Access Compliance Report

Public Rights-of-Way

Intersection ID: 46725	Main Street: FAWN_VIEW_DR	Cross Street: HAMILTON_FOREST_DR	Location: W
ADA ID: 1E1EEA514446	Ramp Type: PerpDiag	Initial Pass/Fail: Fail	Overall Compliance: No
Severity Score: 17.5			
Codes/Mitigation Info/Possible Solution		Field Measurements/Component Compliance

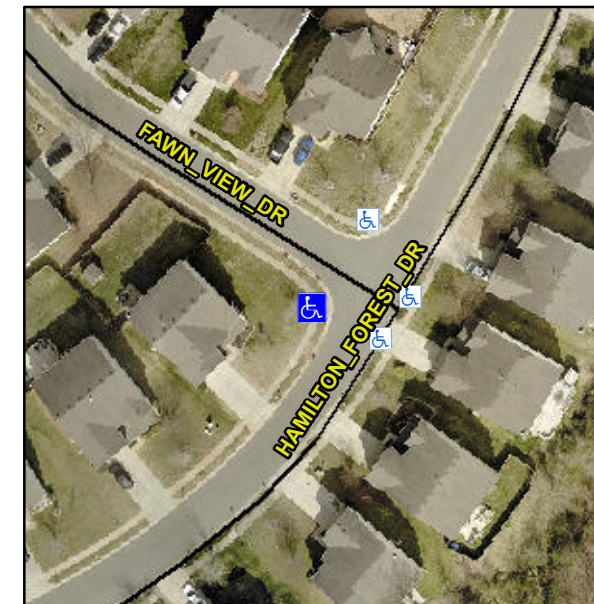
Not Found, R304.5.1

Compliance	Description	Data	Compliance	Description	Data
N/A	Ramp Length (in)	46.5	Yes	Ramp Slope (%)	8.0
No	Ramp Width (in)	33.0	Yes	Ramp XSlope (%)	0.3
N/A	Flare Type LT	N/A	N/A	Flare Type RT	N/A
N/A	Flare Slope LT (%)	N/A	N/A	Flare Slope RT (%)	N/A
N/A	Flare Traversable LT?	N/A	N/A	Flare Traversable RT?	N/A
N/A	Landing Length (in)	N/A	N/A	DWS Provided?	N/A
N/A	Landing Width (in)	N/A	N/A	DWS Contrast?	N/A
N/A	Landing Slope (%)	N/A	N/A	DWS Length (in)	N/A
N/A	Landing X Slope (%)	N/A	N/A	DWS Full Width?	N/A
N/A	Landing Curb? (Y/N)	N/A	N/A	DWS Offset (in)	N/A
N/A	Shared Landing?	N/A			
N/A	Gutter Ponding?	N/A	N/A	Gutter Slope (%)	N/A
N/A	Gutter Lip Ht (in)	N/A	N/A	Gutter X Slope (%)	N/A
N/A	Painted X Walk1?	No	N/A	Painted X Walk2?	No
	X Walk 1 Direction	To SE		X Walk 2 Direction	To NE
N/A	X Walk 1 Width (in)	N/A	N/A	X Walk 2 Width (in)	N/A
	X Walk 1 Slope (%)	0.1		X Walk 2 Slope (%)	0.0
	X Walk 1 X Slope (%)	0.4		X Walk 2 X Slope (%)	0.0

Remove & Replace Curb Ramp With Two New Directional Ramps or Equivalent.
